Medical Device Alert

MDA/2019/038

Syringe driver pumps: T34™ 3rd edition models only – stop using the pump until updated instructions for use and BodyComm™ V3.0 software are released

Images showing the difference between 2nd and 3rd edition pumps:

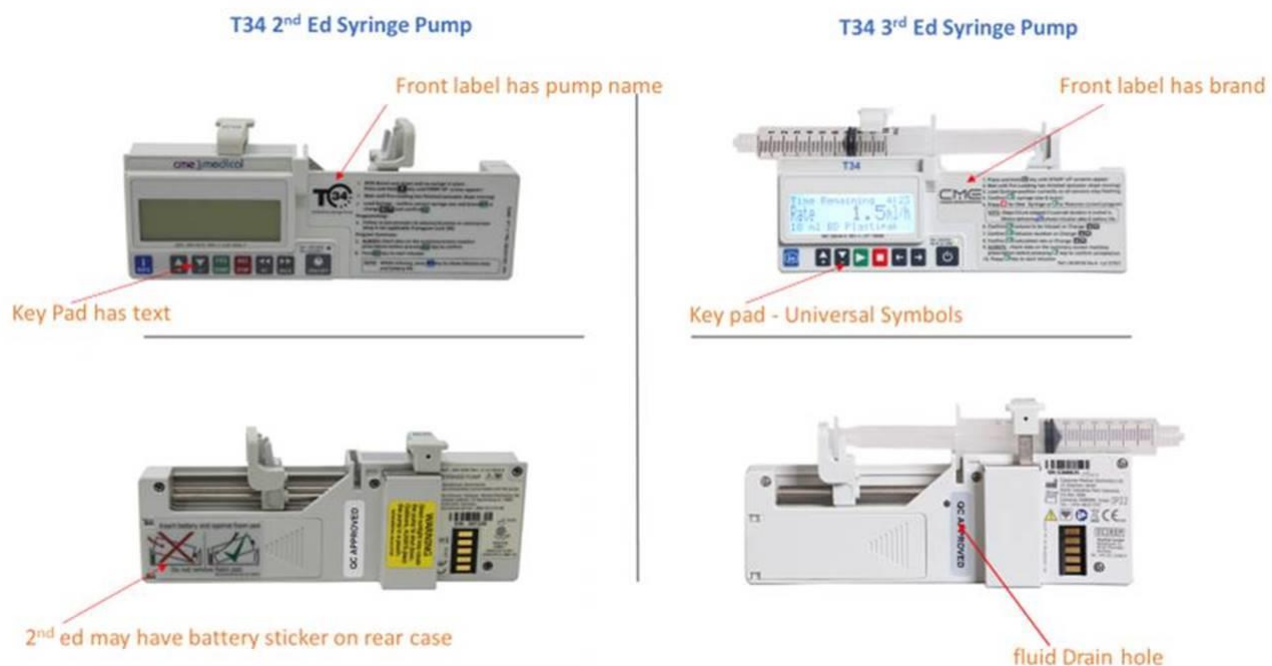
In April 2018 the manufacturer released an updated version of the T34 syringe driver pump, referred to as the 3rd edition.

This was updated primarily to ensure compliance with version 3.1 of the medical electrical equipment and systems standard IEC 60601-1.

- errors and inconsistencies in the instructions for use
- [incompatibility of the BodyComm™ 88-102 software with 3rd edition pumps](#)
- [changes to battery life](#)
- use implications due to change in device interface

- Pumps can be returned to service once the updated IFUs have been received and there is a system in place for the configuration of 3rd edition T34 pumps to only be used with V3.0 BodyComm software. Note: previous versions of the BodyComm software (88-102) are not compatible with 3rd edition T34 pumps (see device details section).
